**August 21, 2014
BOARD OF COUNTY COMMISSIONERS
ORANGE COUNTY, FLORIDA**

**ADDENDUM NO. 8
IFB NO. Y14-748 PH
ORANGE COUNTY EASTERN WATER RECLAMATION FACILITY
PHASE V AND CENTRIFUGE DEWATERING IMPROVEMENTS**

PATH/FILENAME: X:\ORANGE COUNTY\UTILITY\WRF\60222491_FINAL-DESIGN\000_CAD\SHEETS\C-C-511.DWG
 LAST UPDATE: Wednesday, August 20, 2014 9:04:41 AM PLOT DATE: Wednesday, August 20, 2014 9:53:09 AM
 PLOTTED: Robertsonq
 ANSI D - 20-Aug-14

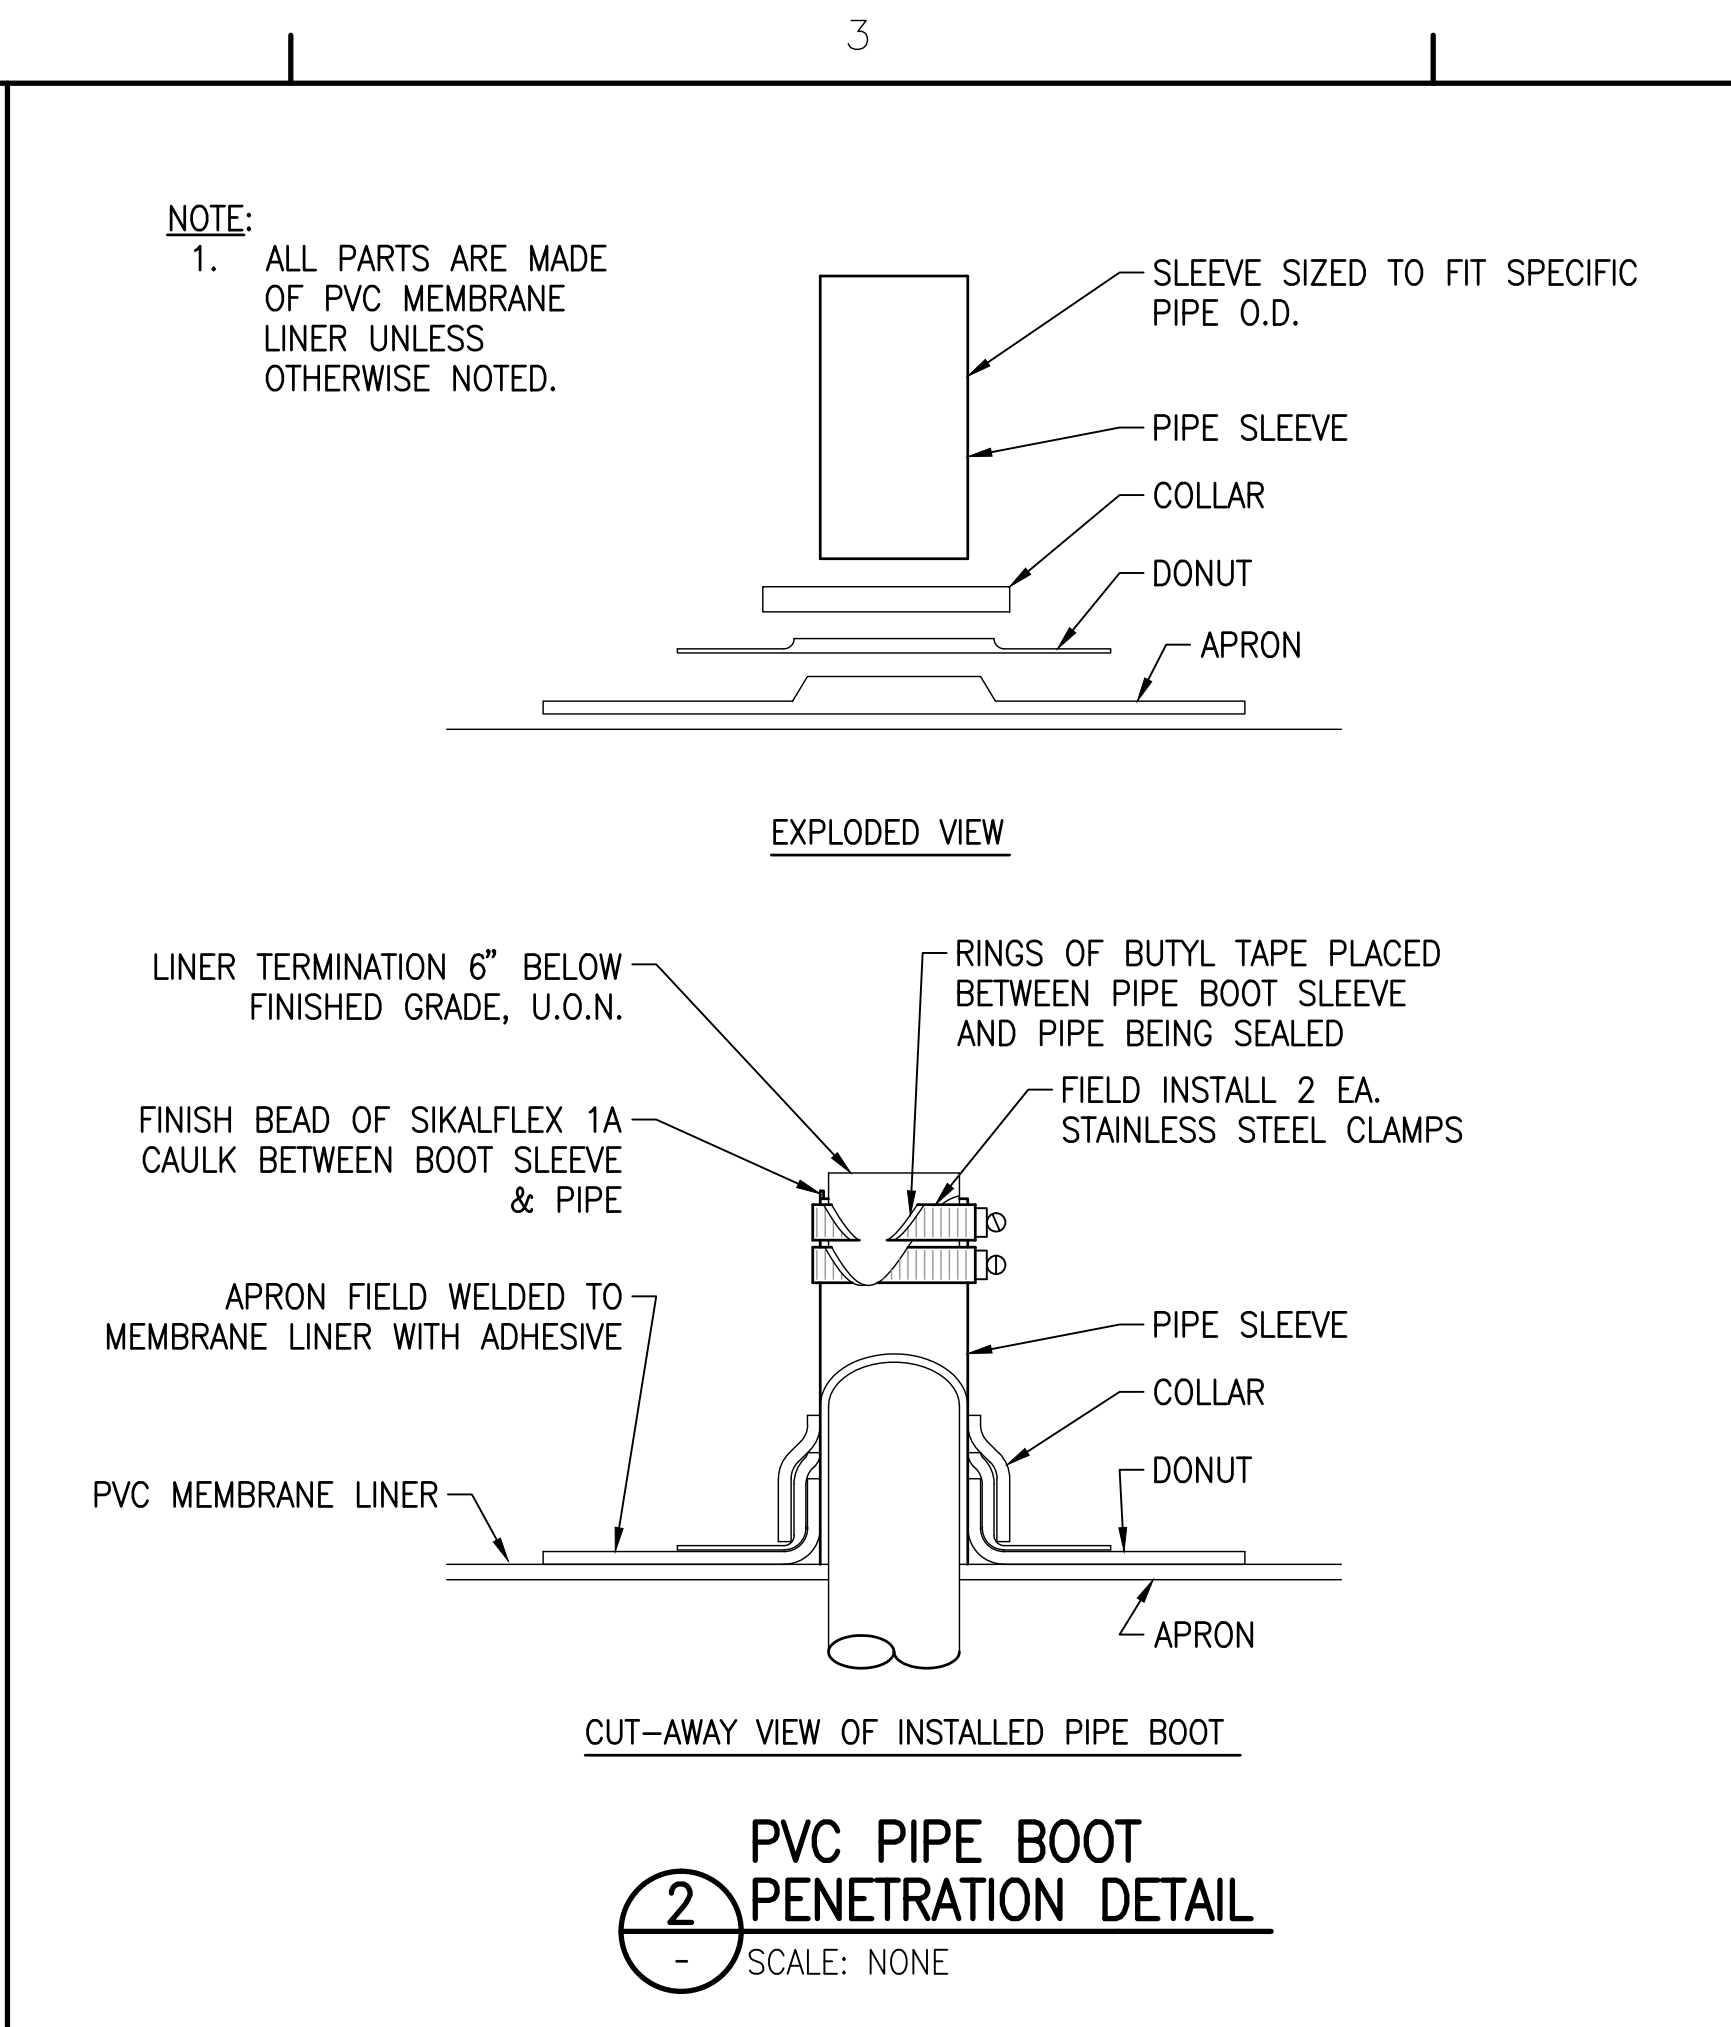
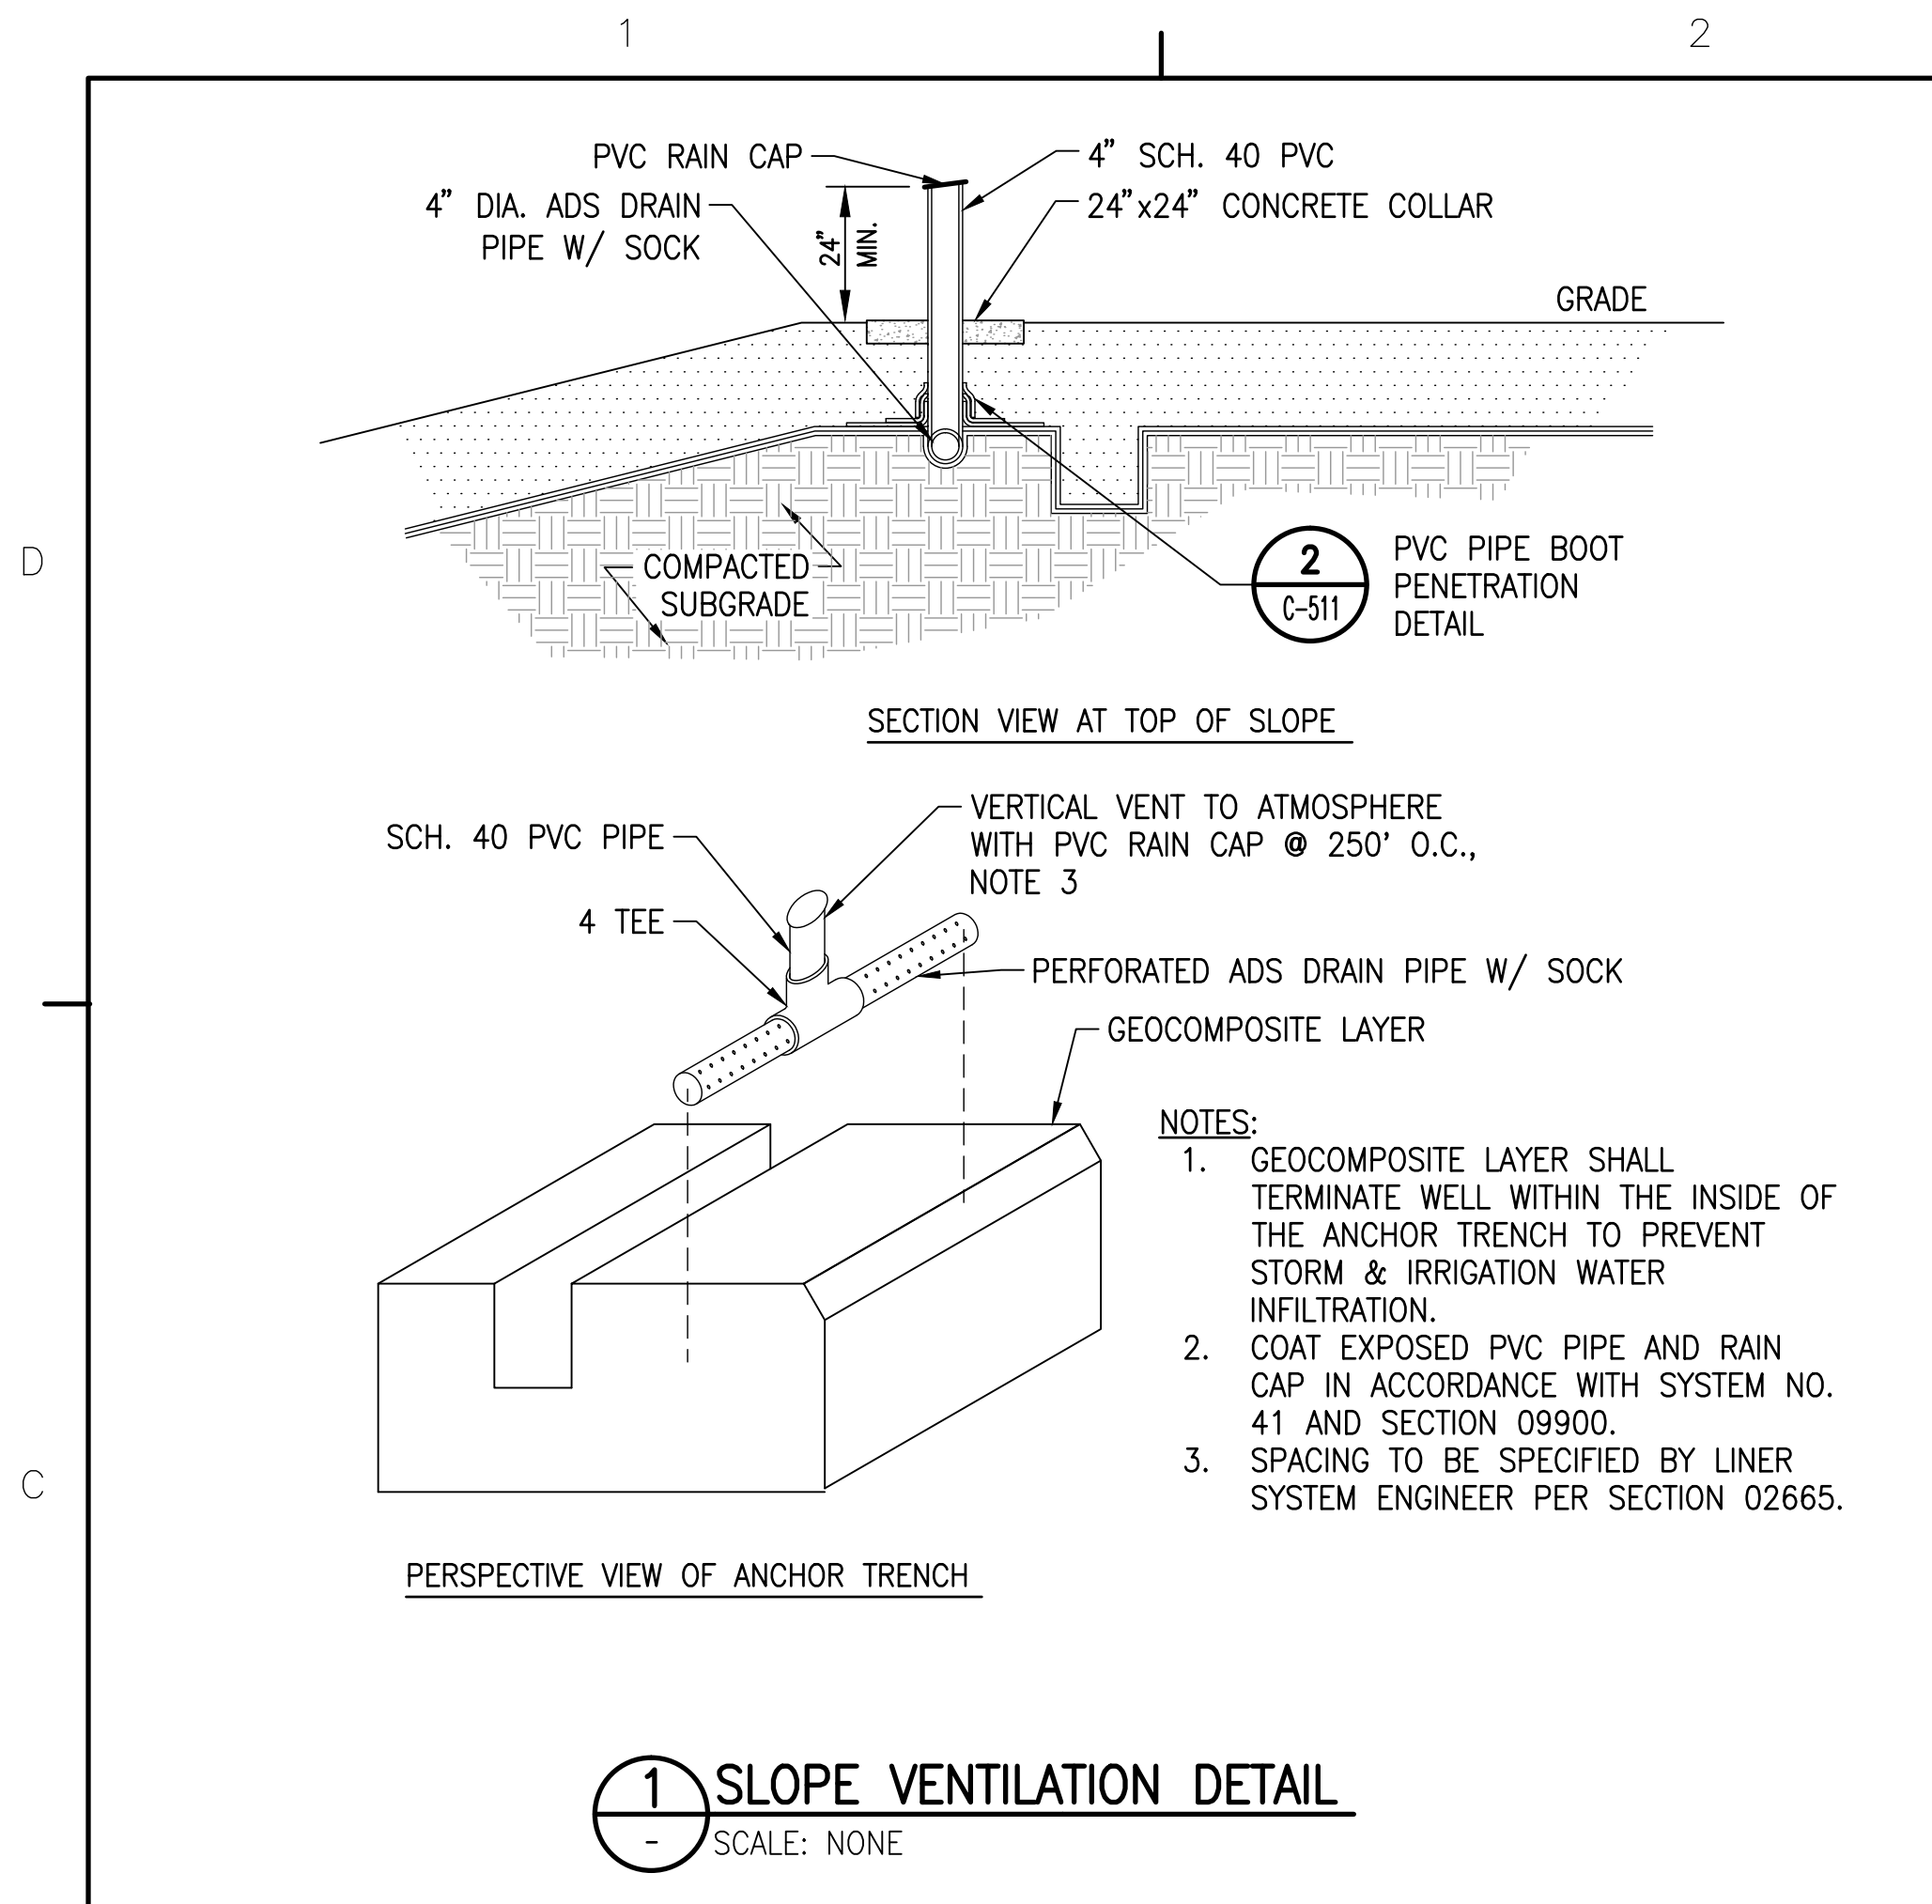
14. Bid Package A: Detail 1 on sheet C-511 references Section 02665 for spacing and locations of the Sch. 40 PVC vents. However, I was unable to find this information in Section 02665. Please provide information regarding the location, quantity, and spacing of the vents.

The Slope Ventilation Detail on Drawing C-511/Detail 1 is revised to note in the perspective view of the detail to include an interval for the vertical vents to be placed at 250' on center around the perimeter of the Reject Storage Pond. Please reference Note 3 on the revised and Specification Section 02665 regarding the responsibilities of the Liner System Engineer to prepare the submittal providing the specific number and location of vents. Note 3 is revised as follows; ~~REFERENCE SECTION 02665 FOR THE CRITERIA TO DEFINE SPACING AND LOCATION OF VENTS~~ SPACING TO BE SPECIFIED BY LINER SYSTEM ENGINEER PER SECTION 02665 (Attachment)
